OUR REF: Q000233  
COUNCIL REF: A005893356

### REQUEST FOR S81 MINOR CHANGE TO DEVELOPMENT APPROVAL (A005893356) LOCATED AT 46-50 LATHAM STREET, CHERMSIDE

The key changes being sought to the approval package are summarised as follows:

Image 1. Approved Basement Level 1

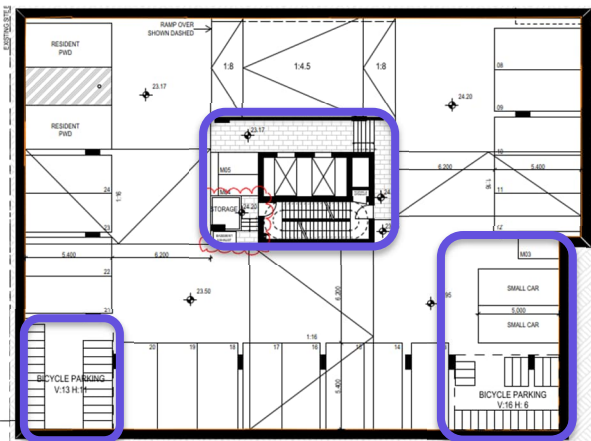
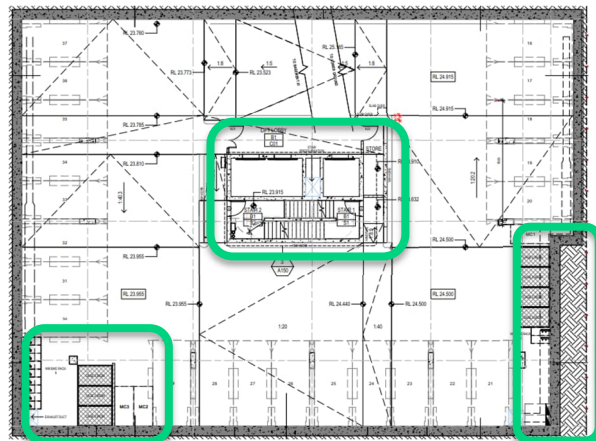
The basement layout has been reconfigured to accommodate an additional lift. The 2 share car parking spaces on the lower ground floor have been removed. However, the number of residential and visitor spaces remains unchanged. There are inconsequential changes to the location of bicycle spaces, and the inclusion of additional storage are also proposed across the approved basement and lower ground floor levels.

- Reduced floor to ceiling heights;
- Inclusion of a plenum and a landscape planter above;
- New fire stairs in the front setback;
- Additional fire stairs and lift shaft;
- Removal of café ancillary plant and waste;
- Servicing area increased from 11.0m x 3.5m to 11.5m x 4m;
- Dedicated van parking area removed;
- Removal of shared car parking spaces;
- Decrease in motorcycle parking spaces to 5; and
- Increase in bicycle parking spaces from to 87.

**Figure 2: Proposed and approved lower ground floor level**

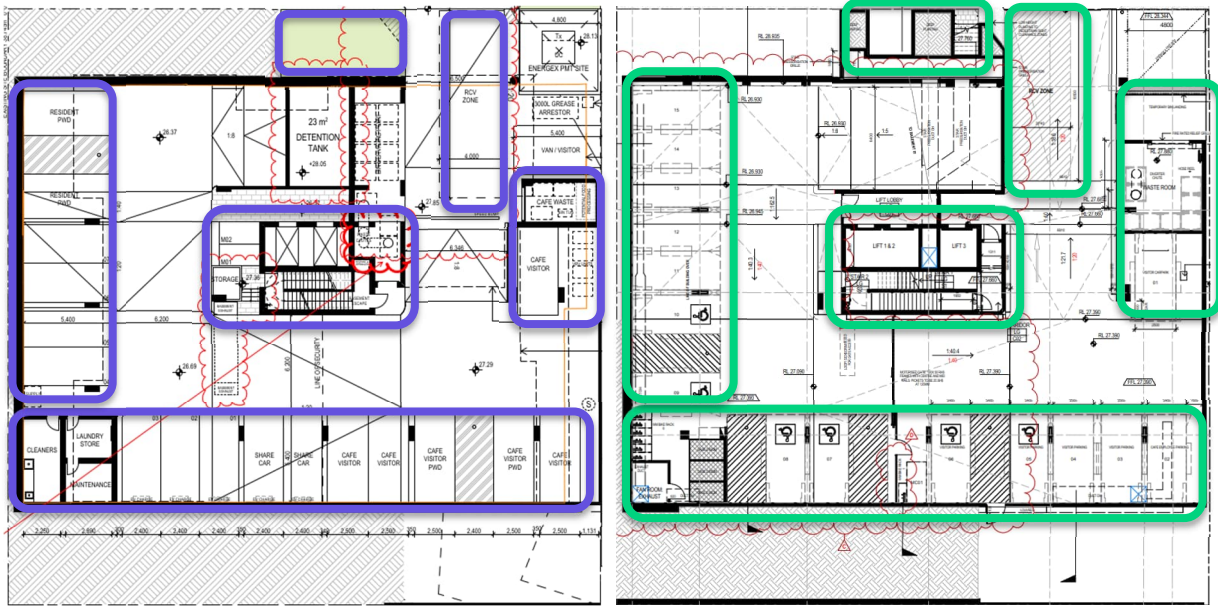
**Figure 3** shows the extent of changes between the approved and proposed lower ground floor.

**Figure 3: Proposed and approved ground floor changes**

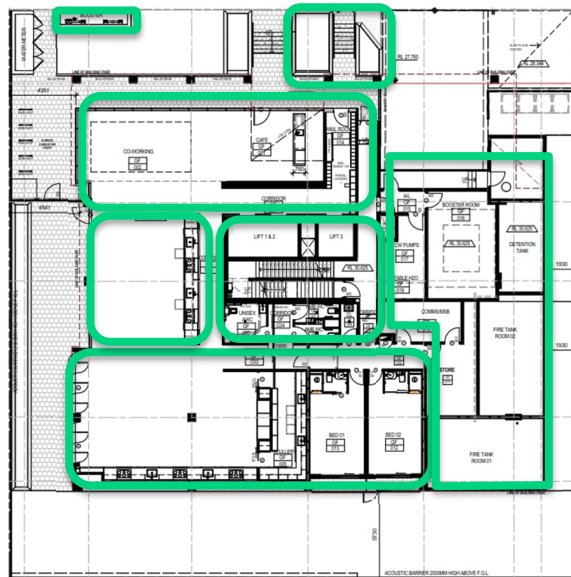
The proposed changes to the ground floor area include a new set of fire stairs and relocation of booster and pump, reconfiguration of deep planting on the site frontage, changes to hard and soft landscaping, and internal reconfiguration to consolidate tenant and non-tenant spaces.

- Additional lift shaft;
- Relocated booster room and water metre;
- Reconfigured office and food and drink outlet areas;
- Shifting the two units to the west to accommodate the larger communal area;
- Change to plant room layout;
- New fire stairs on site frontage;
- Reduction of deep planting in the front setback from 66m<sup>2</sup> to 23.22m<sup>2</sup>, including the incorporation of raised planter beds in lieu of deep planting;
- Reduction of deep planting in the rear setback from 137m<sup>2</sup> to 126m<sup>2</sup>; and
- Removal of awning towards the western boundary.

**Figure 4: Proposed and approved floor levels**

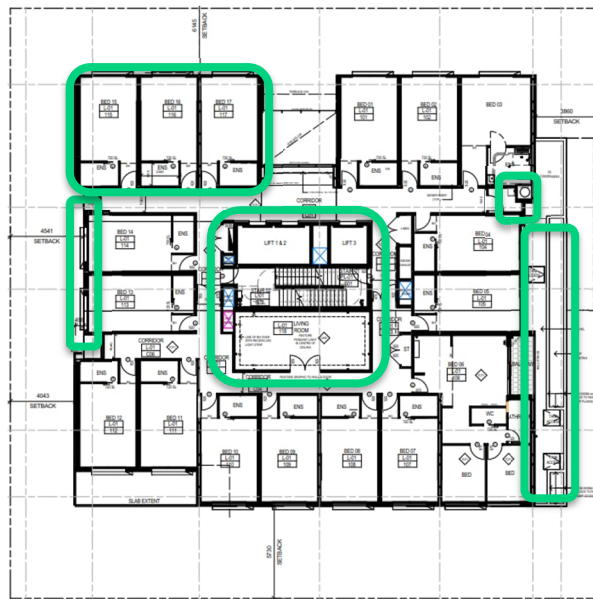
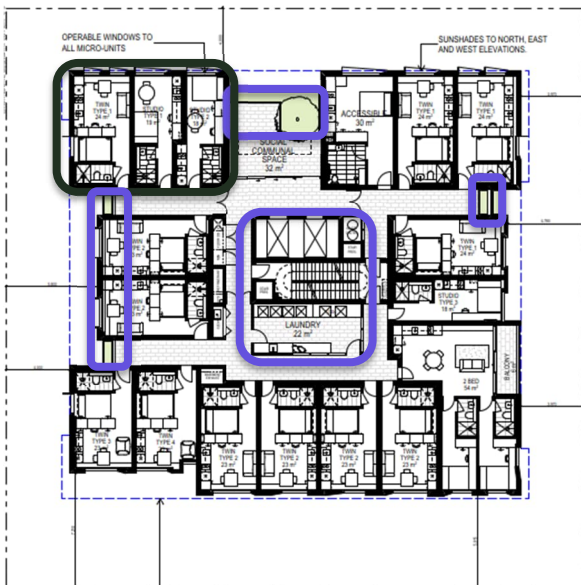
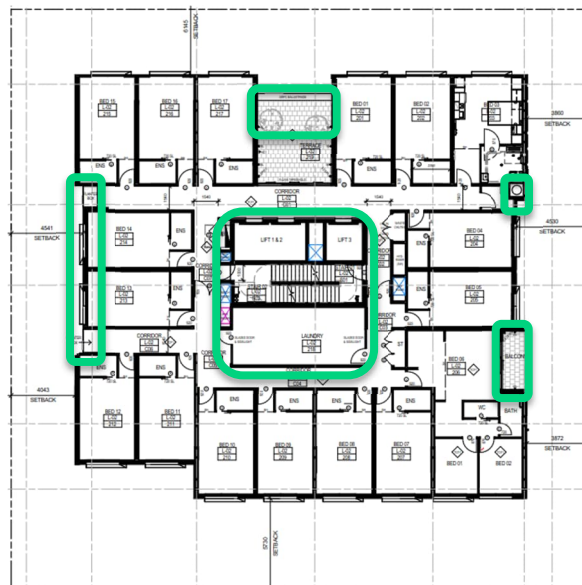
The key changes to Levels 1-8 include the additional lift, reconfigured lift core and additional communal open spaces. These amendments have resulted in changes to setbacks to all properties boundaries.

- Additional lift shaft;
- Reconfigured lift core;
- Amended setbacks as follows:

- Increased front setback from 4m to 4.145m;
- Amended side (east) setback from 3.97m to 3.87m;
- Increased side (west) setback from 4m to 4.043m;
- Amended rear setback from 5.815m to 5.73m;
- Increased internal communal open space on each level;
- The 2 x Studios Type 1 units in the northwestern section of the building replaced by 2 x Studio;
- Removal of the east facing window in the southeastern unit;
- New fire door to the eastern maintenance area.

**Figure 6: Proposed and approved roof top**

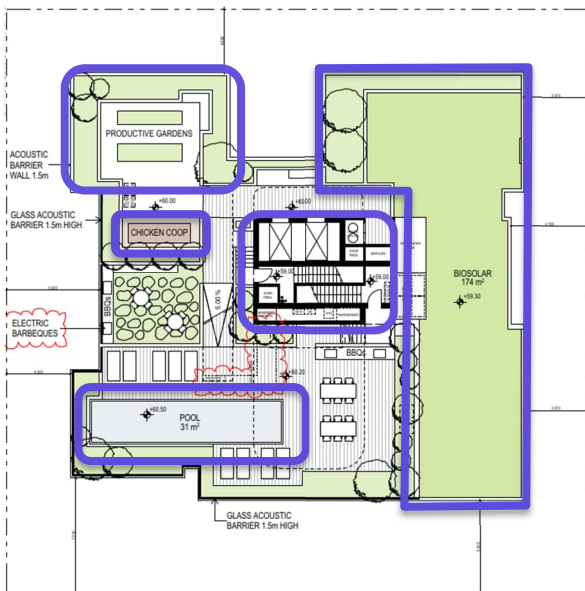
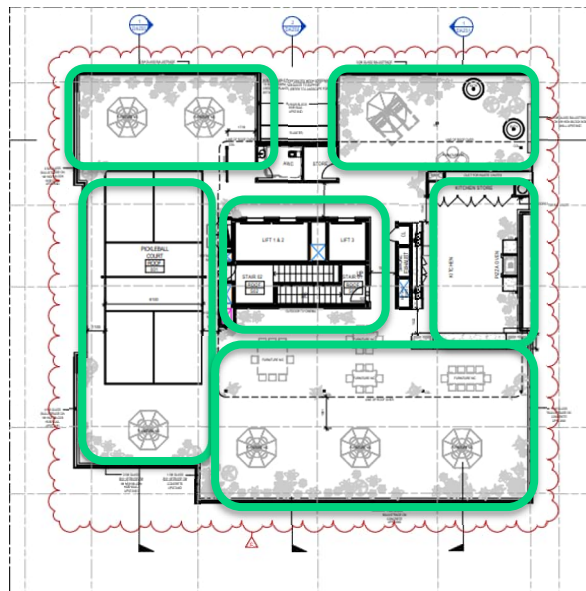
The proposed changes to the rooftop include the removal of the biosolar and productive gardens to accommodate solar panels and more communal open space.

- Increase in lift shafts from 2 to 3;
- Reconfigured lift core;
- Reduced building height from 65.75m AHD to 64m AHD;
- Removal of the chicken coup, biosolar area, productive garden and pool;
- Introduction of solar panels; and
- Inclusion of additional BBQ and seating areas, pickle ball court and toilet.
